ADDENDUM #2
ALLEN AVENUE SANITARY SEWER REPLACEMENT GP-1332 PART 1
14TH STREET WATERLINE REPLACEMENT PART 2
CITY OF CANTON

Friday, February 11, 2022

This Addendum is being issued to provide additional clarification on the plan sheets, additional information related to the project including plan notes and details, and to respond to questions submitted by Bidder's during the written question's submittal period.

SIDE STREET CONNECTION

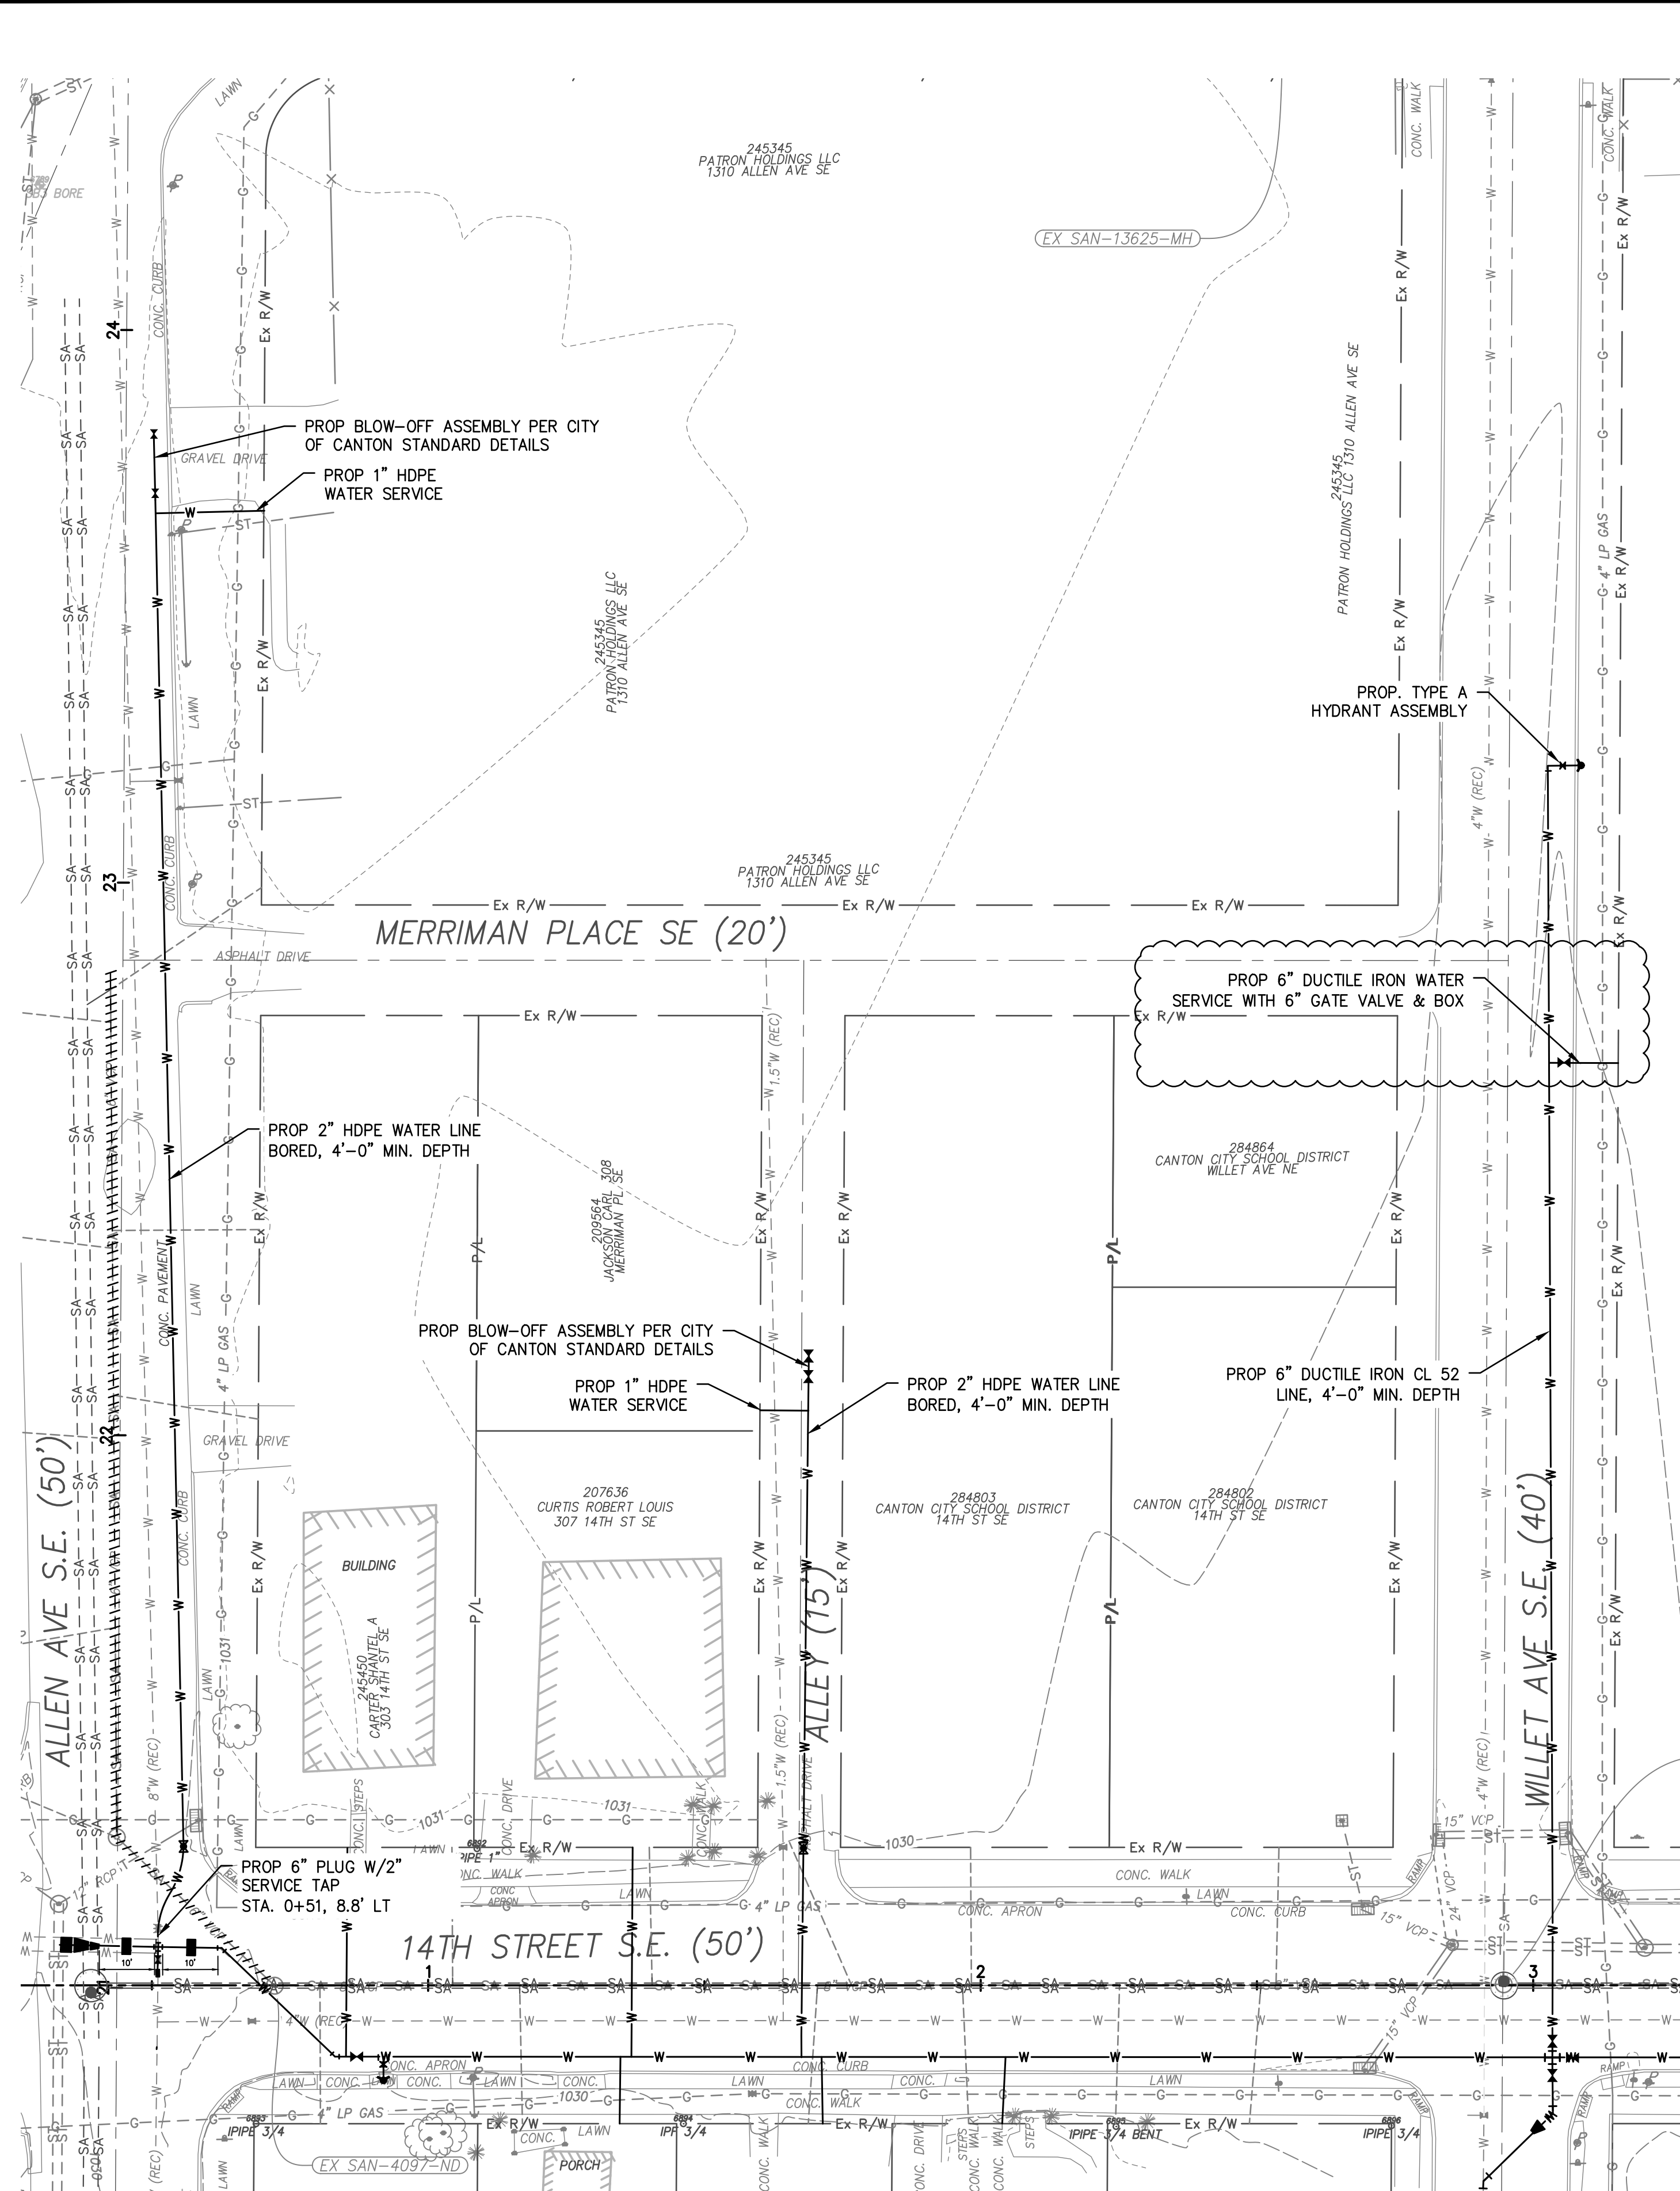
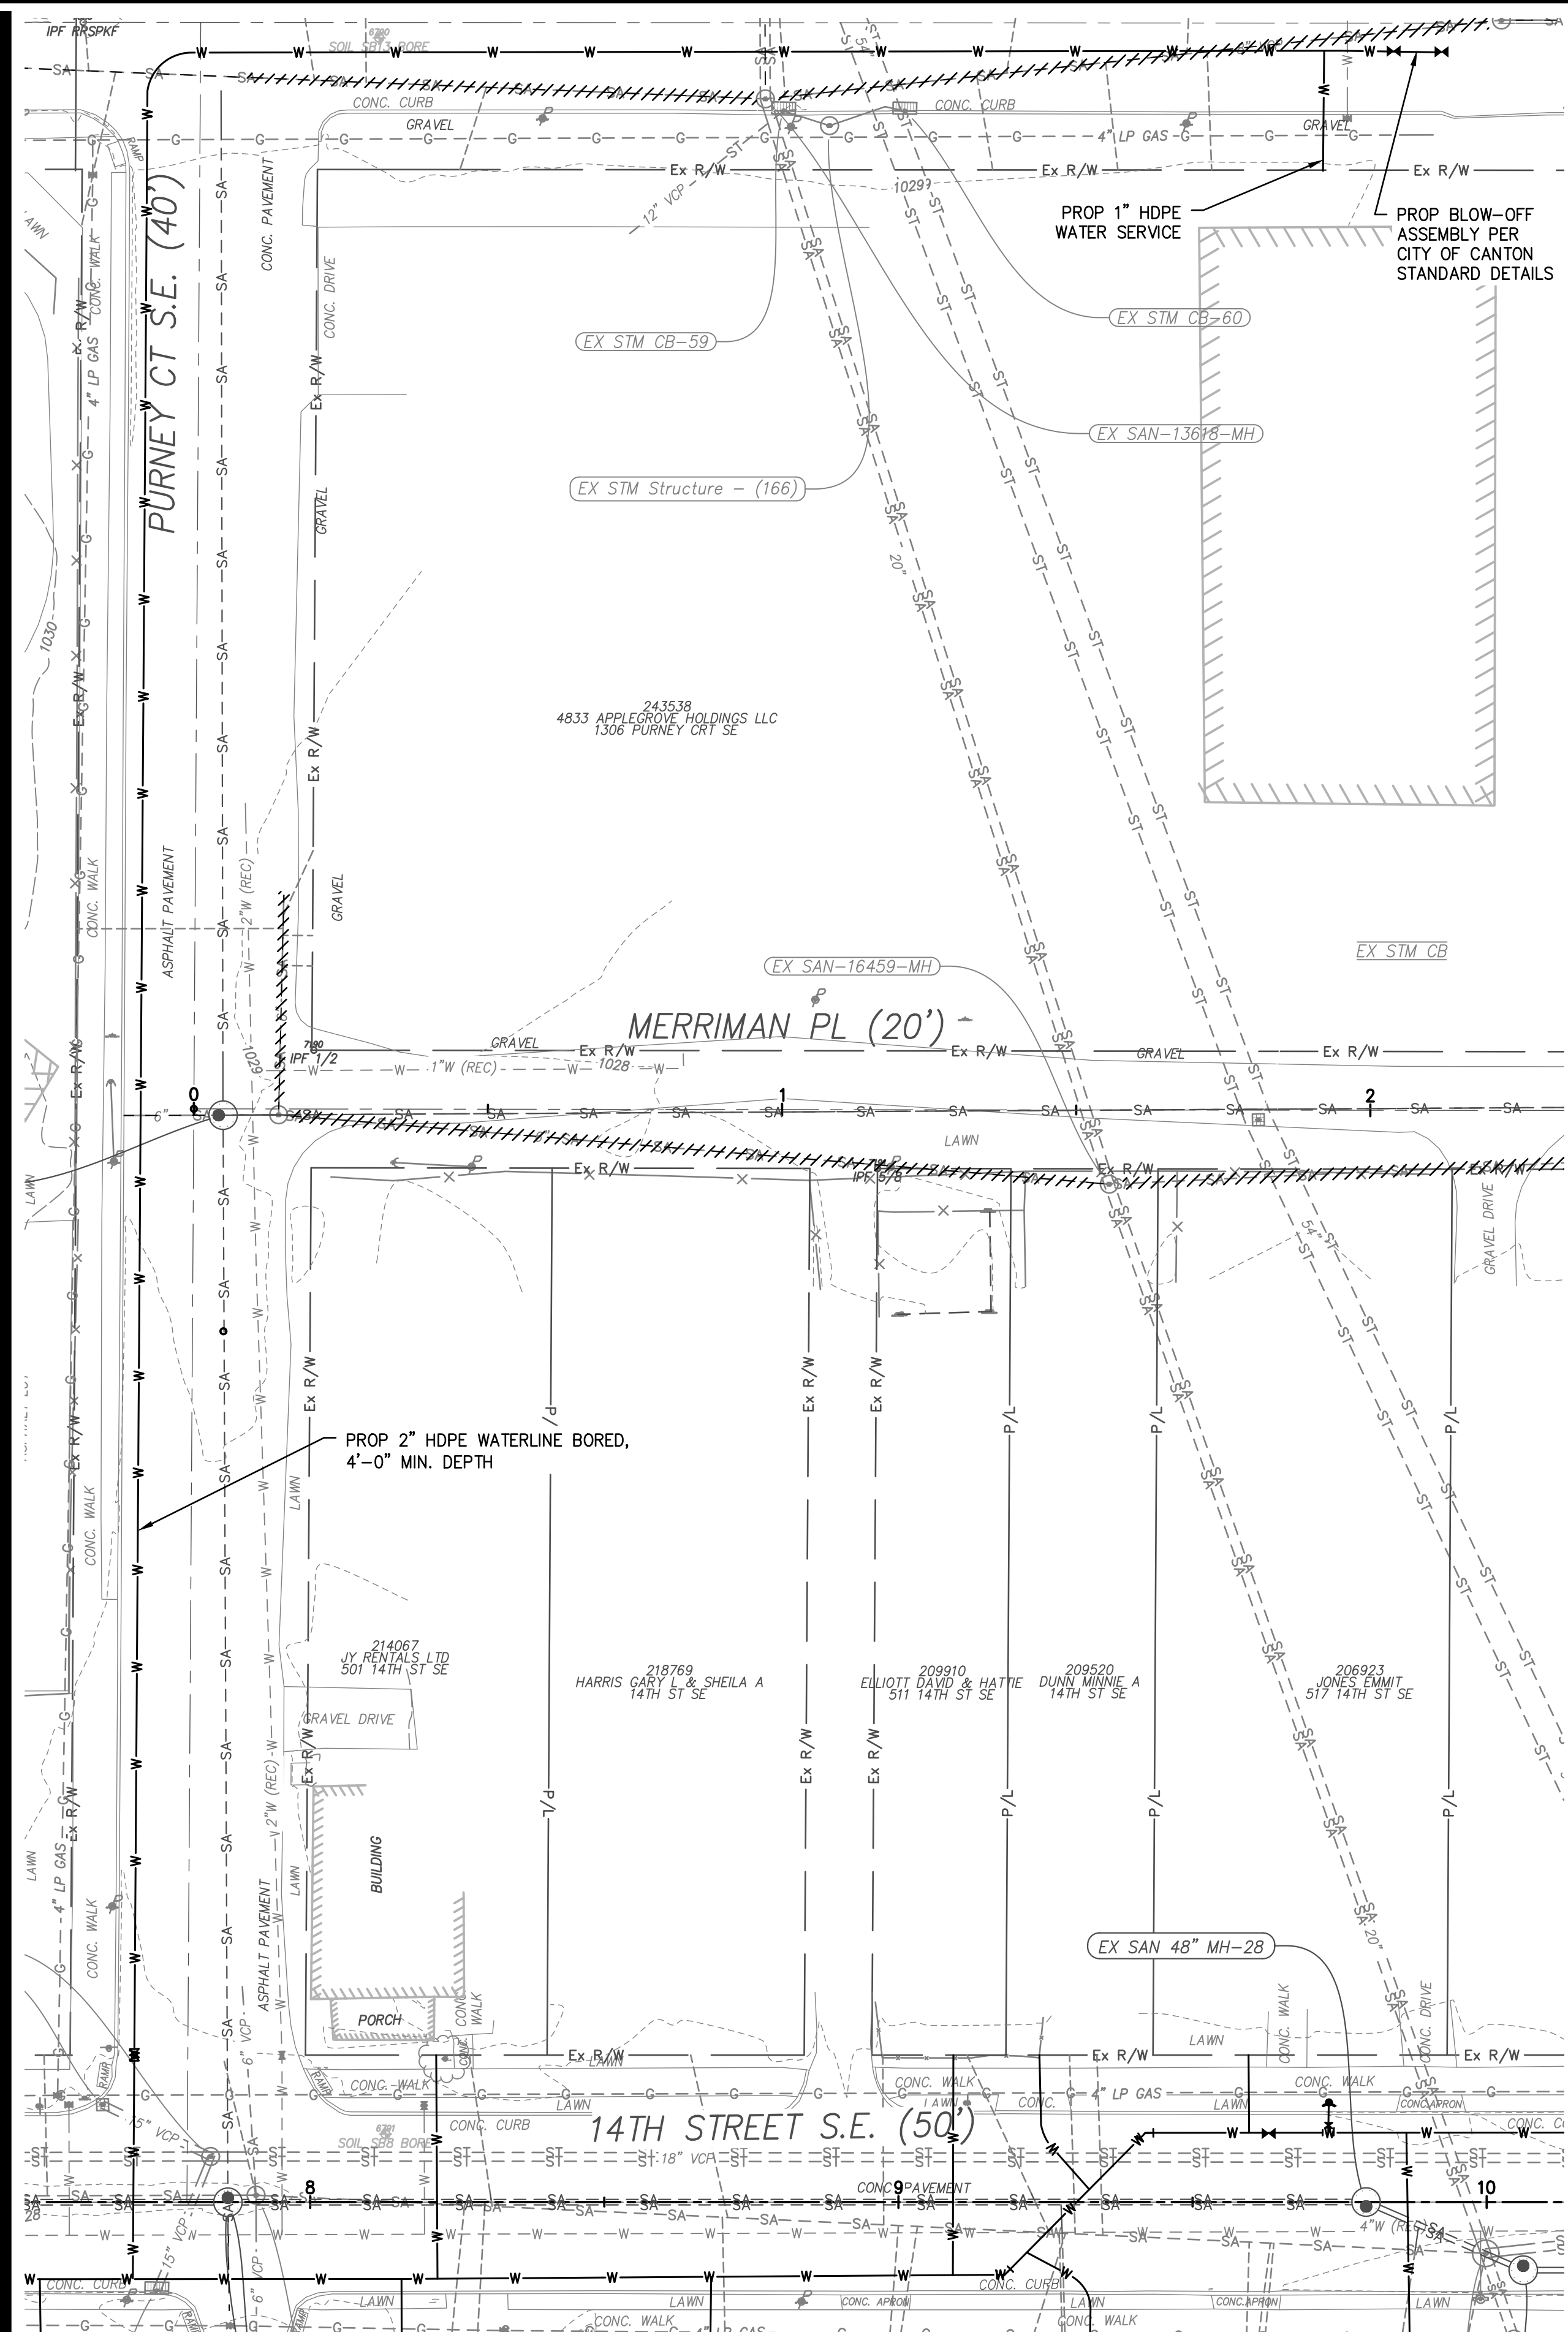
On sheet #11 (water plans) it shows a 6" water service on Willet Avenue. Is this a new service or a reconnection to existing? Will a valve be required? **This is the reconnection of an existing water**

service. We have added a valve for isolation, and it's reflected in the general summary and the bid proposal form.
